State of New Mexico
ENVIRONMENT DEPARTMENT
Hazardous & Radioactive Materials Bureau
2044 Galisteo Street
P.O. Box 26110
Santa Fe, New Mexico 87502
(505) 827-1557
Fax (505) 827-1544

March 23, 1999

RE: HRMB Recommendations Concerning the Proposed Watershed and Aggregate
Prioritization, Los Alamos National Laboratory, NM 0890010515

TABLE 5.1: SUMMARY OF WATERSHED AND AGGREGATE PRIORITIZATION

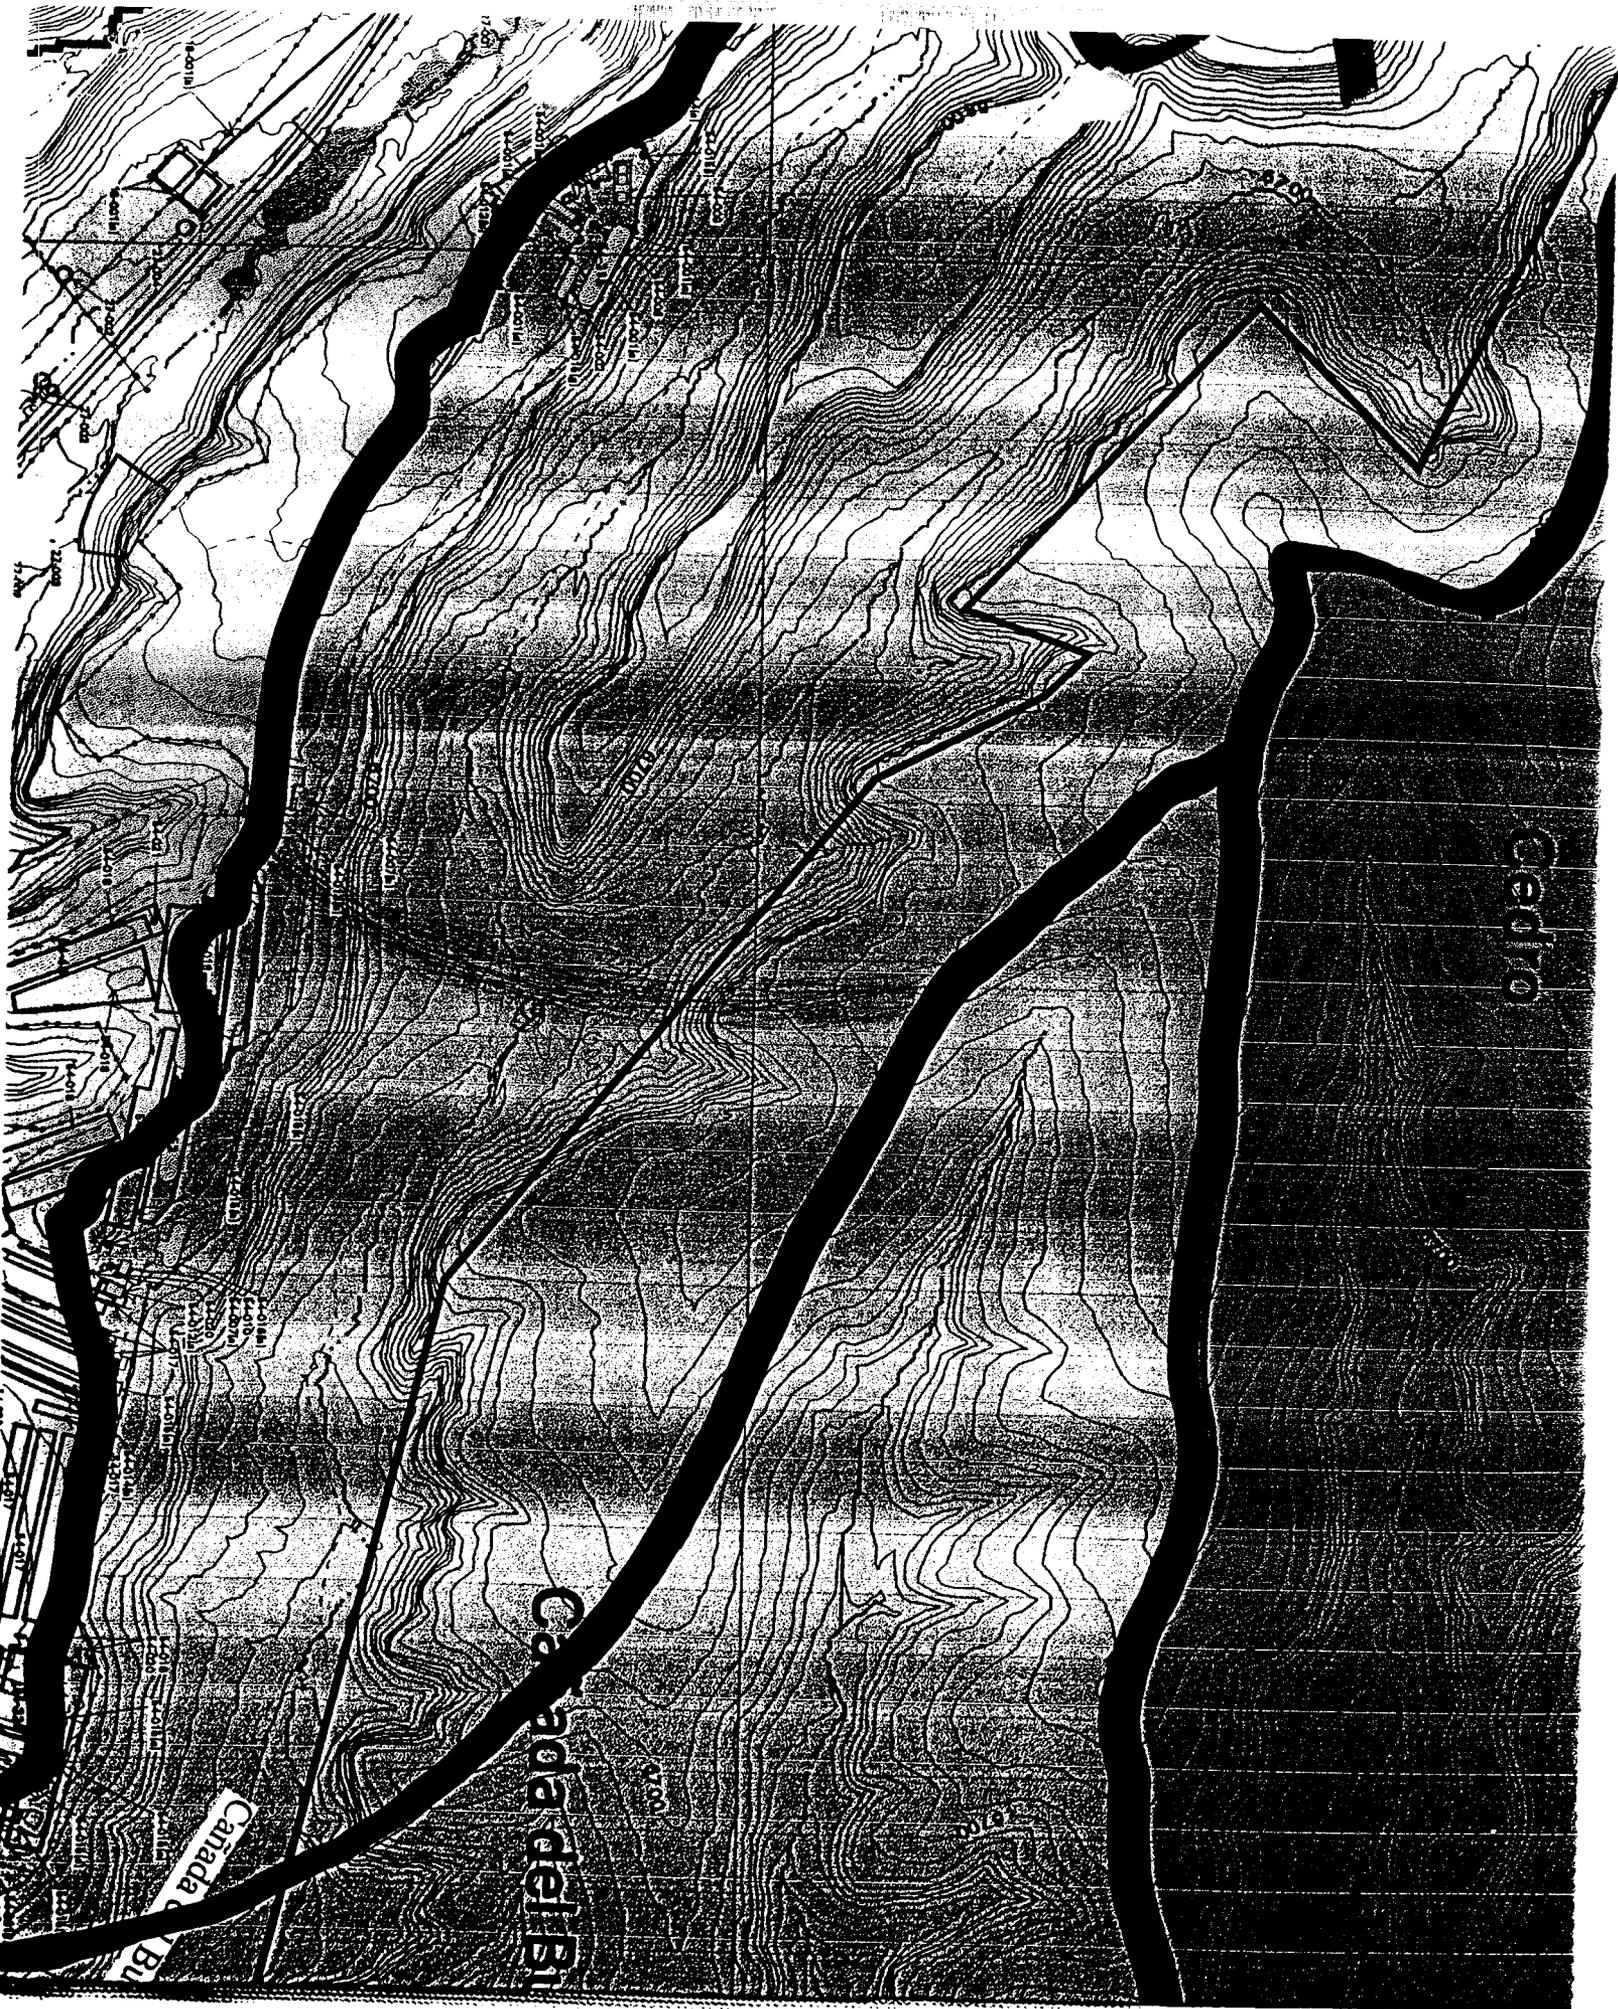
- Move the LA/Pueblo watershed ahead of the Mortandad watershed in priority. The rationale for RPMP's recommendation is as follows: 1) the LA/Pueblo Canyon investigation has progressed; data and interpretation are available 2) high priority sites abound TA-21, ash pile, hillsides, etc. 3) easier accessibility, (human health issues) 4) the Mortandad Canyon investigation is in the initial stages of data collection.

Create another aggregate (Aggregate 6) below the reach at the LA/DP canyon confluence. Aggregate 6 is suggested to have a low ranking and while ranking Aggregates 4 and 5 as medium and high priorities respectively (see attached maps).

Aggregate 1 - Upper Mortandad, change from a high to medium priority. Although this aggregate includes effluent canyon, TA-50's treatment facility outfall, most of the impacts to the surface and subsurface are likely to or have occurred in Aggregate 2 from historic and current releases from both TA-35 and TA-50.

Aggregate 2 - Middle Mortandad/Ten-Site change from a medium to high priority. Also, move the eastern boundary east of sediment traps, most of the contaminant transport (both surface and subsurface) occurs in this stretch of the Mortandad/Ten-Site Canyon watershed.

Extend the eastern boundary of Aggregate 2 to include the Mortandad Canyon reach M-4 or to at least include the sediment traps. RPMP believes this to be appropriate as the majority of surface water, ground water, and potential for surface and subsurface contaminant migration concerns occur in this stretch of Mortandad Canyon (See attached map).

Aggregate 5 - Middle Cañada del Buey, change from a low to medium priority due to surface water concerns with mercury and plutonium from TA-46 and TA-54.

Aggregate 6 - Lower Mortandad/Cañada del Buey, change from a high to low priority. Also, move the western aggregate boundary to the gaging/monitoring station located below MDA G at TA-54. Currently there does not seem to be immediate threat to human health and the environment in this aggregate and land transfer issues should not influence prioritization (see attached maps).

Aggregate 2 - Starmer/Upper Pajarito, change from a low to medium priority due to high explosive releases to surface water and springs in the area.

Aggregate 3 - Three Mile, change from a low to medium priority due to High Explosive releases to surface water and springs in the area.

Aggregate 1 - North Ancho, change from a low to medium priority due to known and potential impacts to groundwater and surface water (high explosives, nitrates, mercury, etc.).
